March 24, 2017

L-MT-17-010  
10 CFR 50.90

Monticello Nuclear Generating Plant License Amendment Request: Revision to Emergency Plan Staff Augmentation Response Times

**LICENSE AMENDMENT REQUEST:  
REVISION TO EMERGENCY PLAN STAFF AUGMENTATION RESPONSE TIMES**

Figure 13.1  
MONTICELLO PLANT EMERGENCY ORGANIZATION

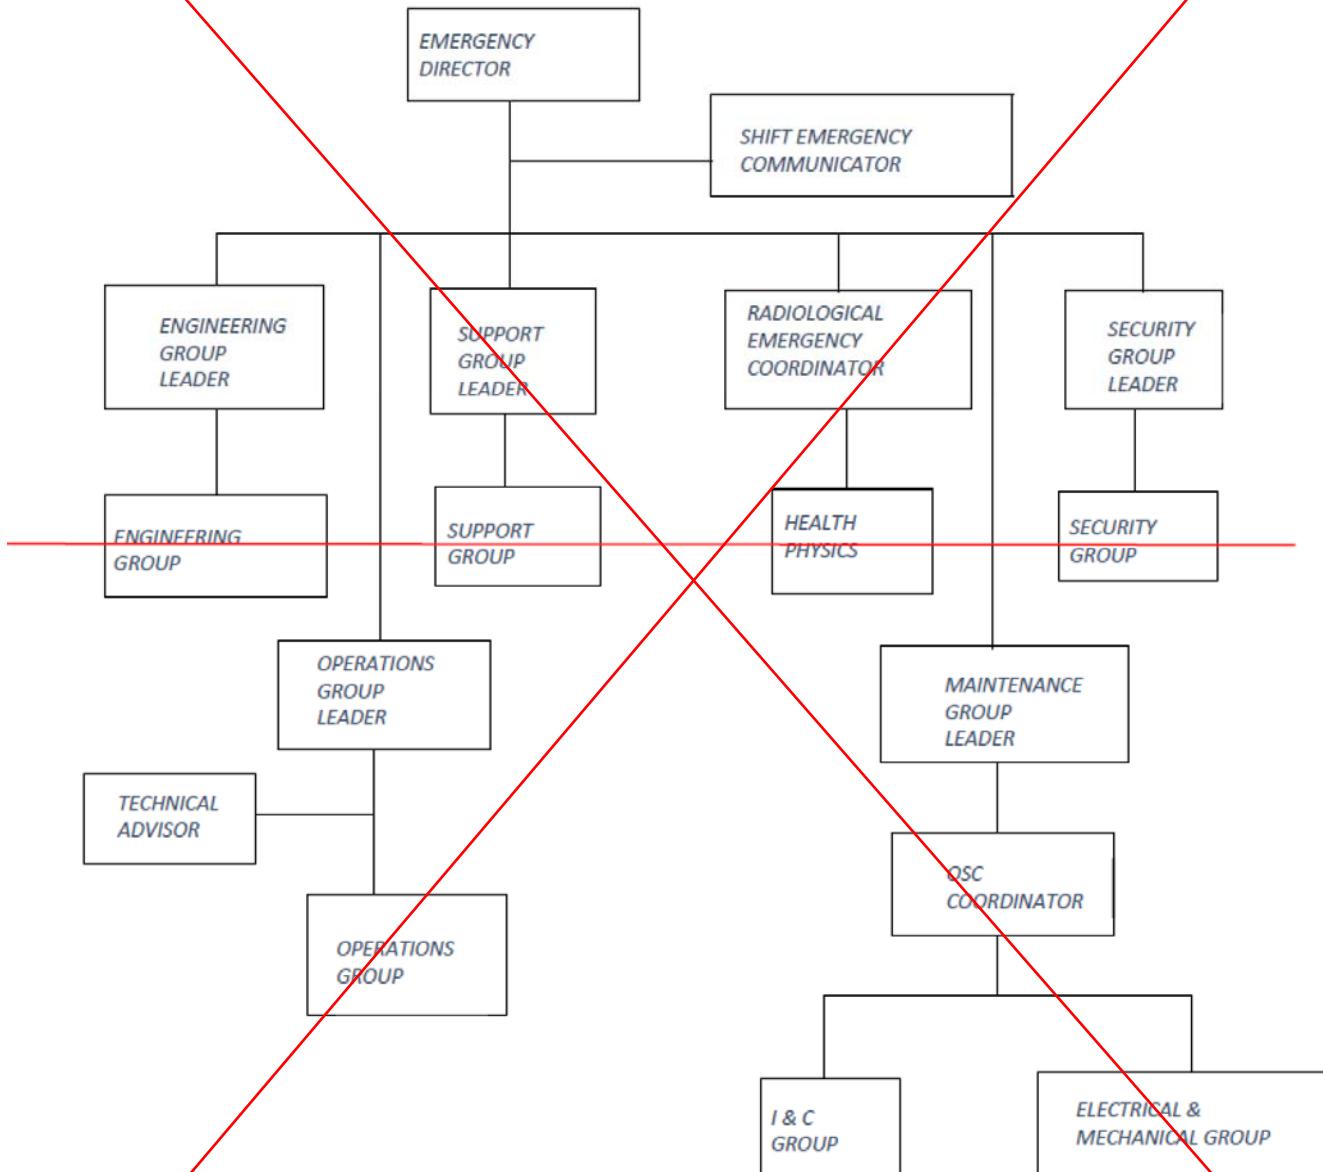
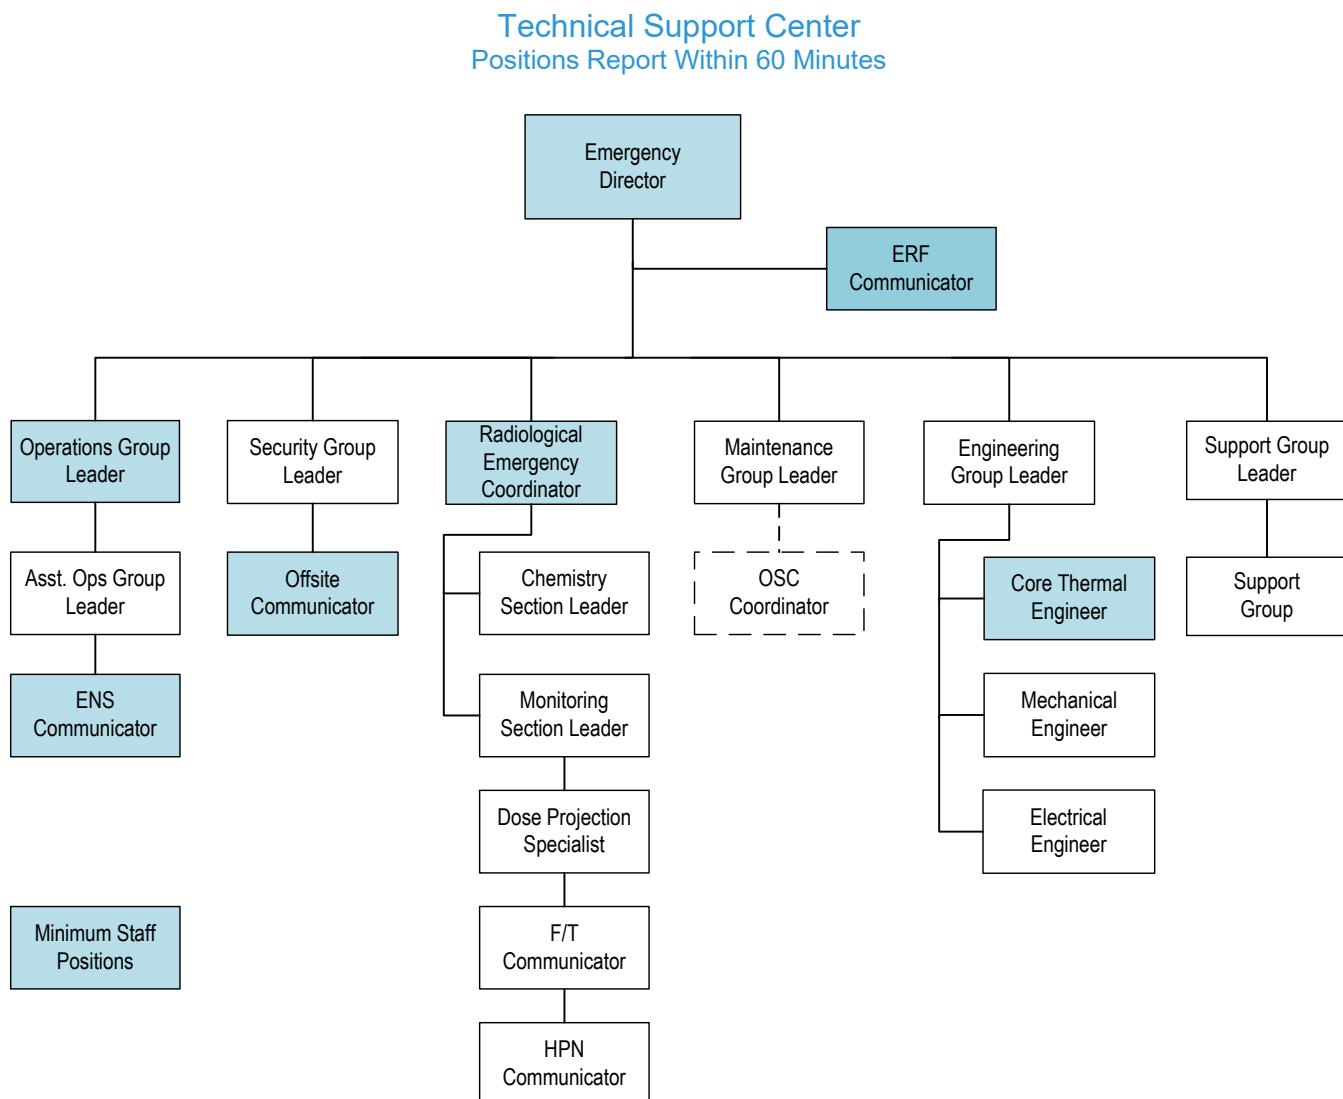
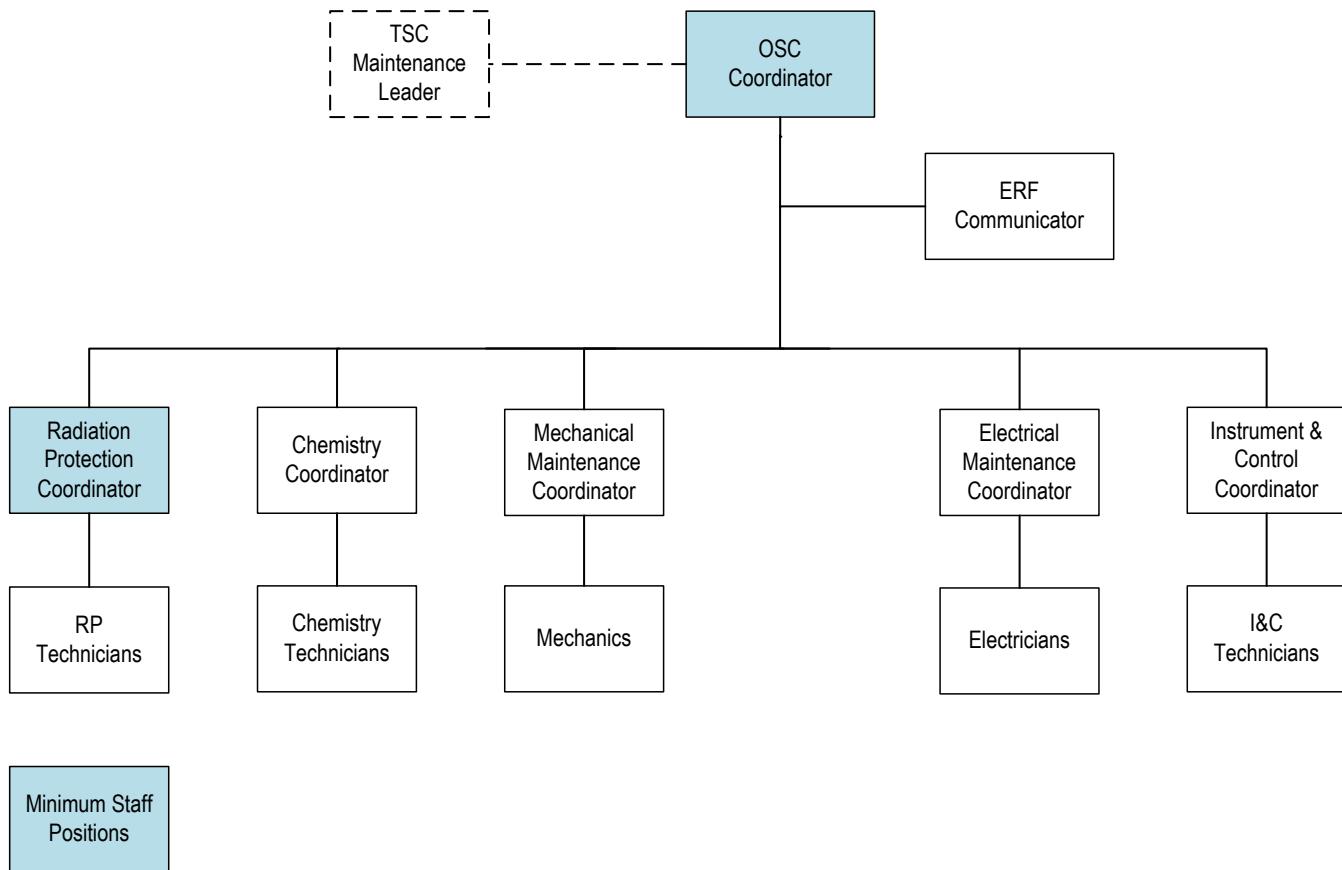
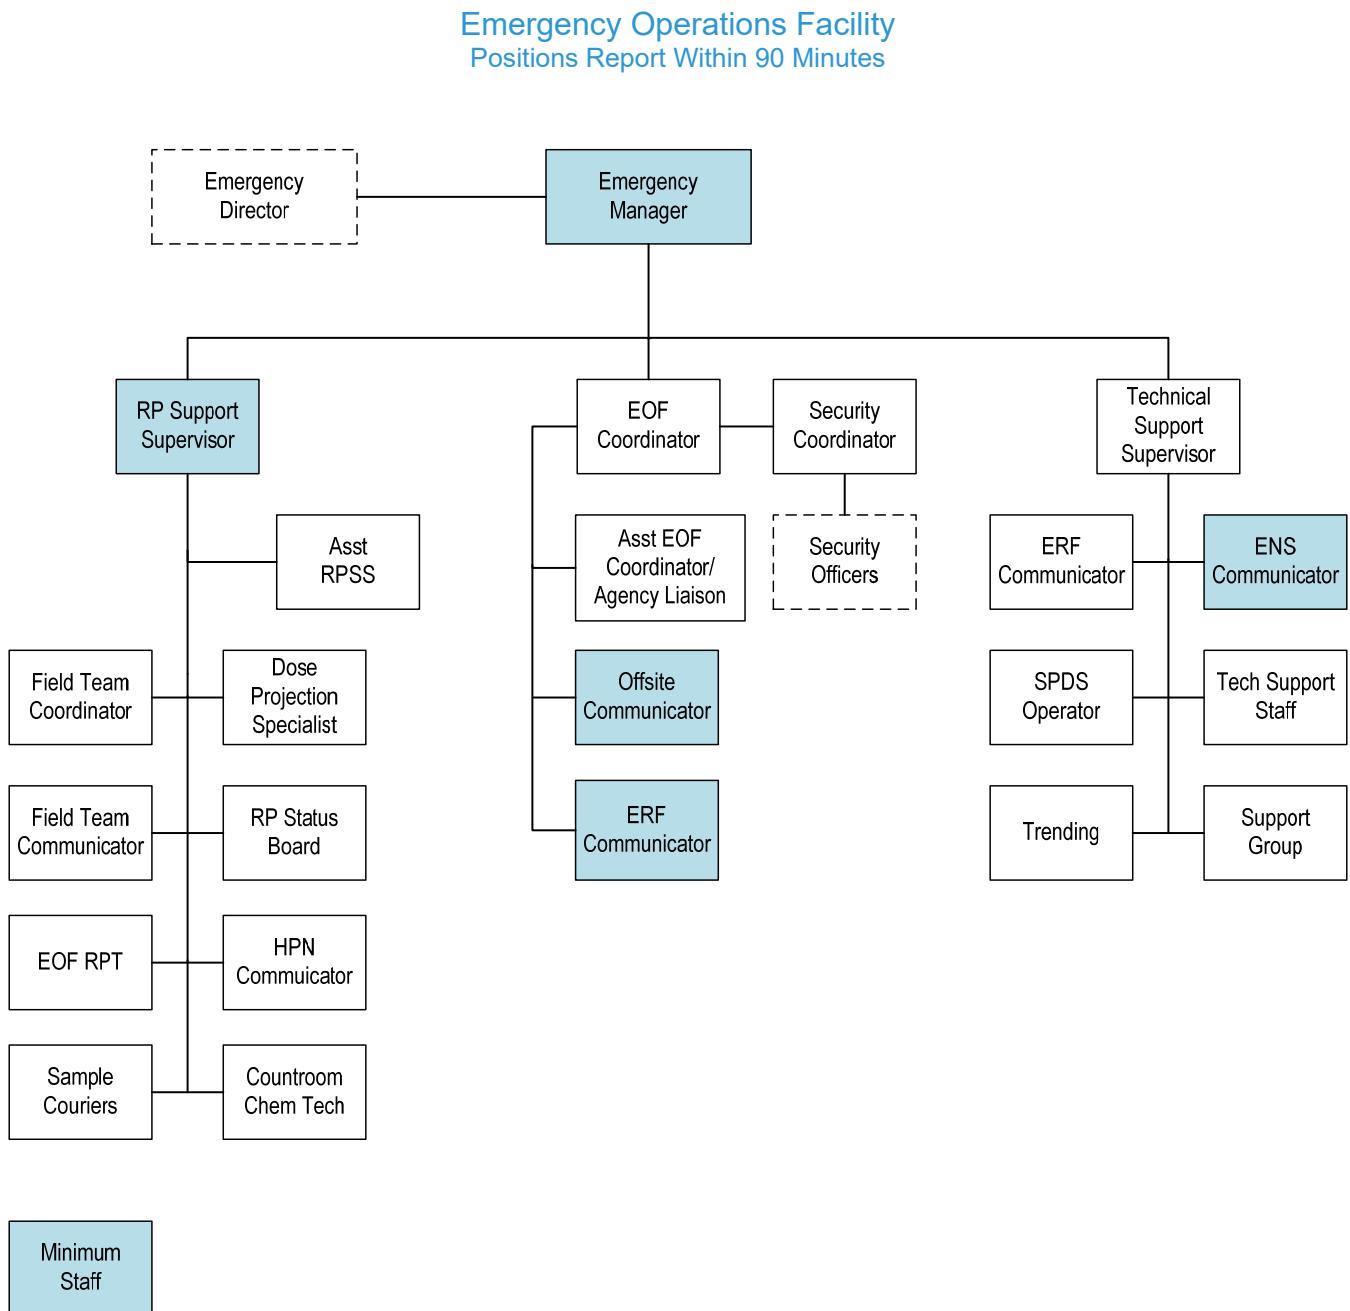
- n. Table 2, “Monticello Plant ERO Responsibility Matrix,” deleted table and replaced with Figure 13.1 to better describe augmented ERO structure.
  - o. Section 6.1.2.6, “Alert,” revised action for dispatch of on-site and off-site survey teams to remove ‘as necessary’ consistent with the proposed change to staff augmentation times.

- r. Section 9.5, “Long Term Recovery,” changed ‘activated’ to ‘entry into’ to maintain alignment for use of ‘activated’ throughout the document.
  - s. Section 13.0, “Figures,” specifically Figure 13.1 was changed to separate TSC, OSC and EOF organizational structures and identify minimum staffing positions required for facility activation.

This Figure is superseded entirely. See revised Figure provided on the next 3 pages.

The proposed revision to the MNGP E-Plan, Figure 13.1 identifies the following minimum staff positions in the TSC which support activation of the facility within 60 minutes of an Alert declaration:

The proposed revision to the MNGP E-Plan, Figure 13.1 identifies the following minimum staff positions in the OSC needed to support activation of the facility within 60 minutes of an Alert or higher declaration:

The proposed revision to the MNGP E-Plan, Figure 13.1 identifies the following minimum staff positions in the EOF which support activation of the facility within 90 minutes of an Alert declaration.

FIGURE 13.4  
HEALTH PHYSICS GROUP ORGANIZATION

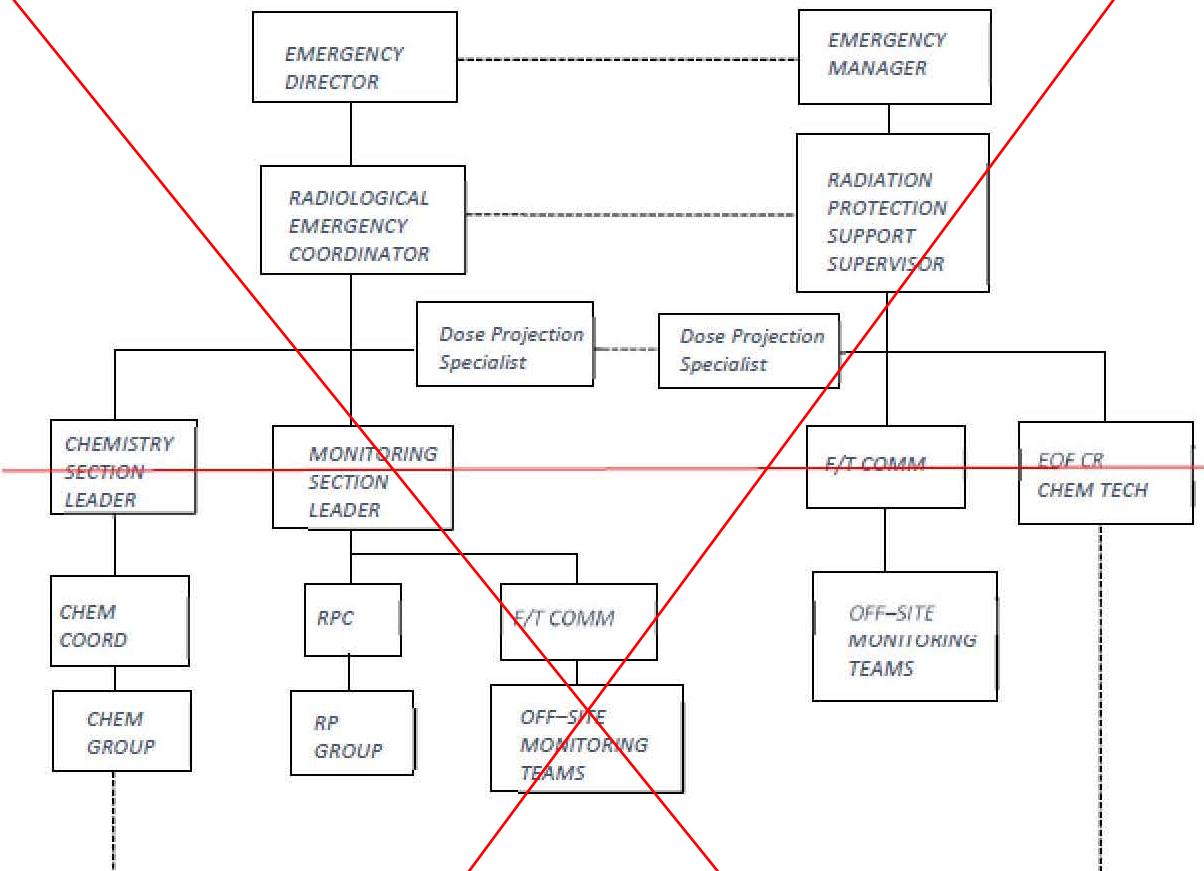
- t. Section 13.0, “Figures,” Figure 13.4 was deleted as the health physics organization was subsumed by the new charts in Figure 13.1.

This Figure is removed entirely.
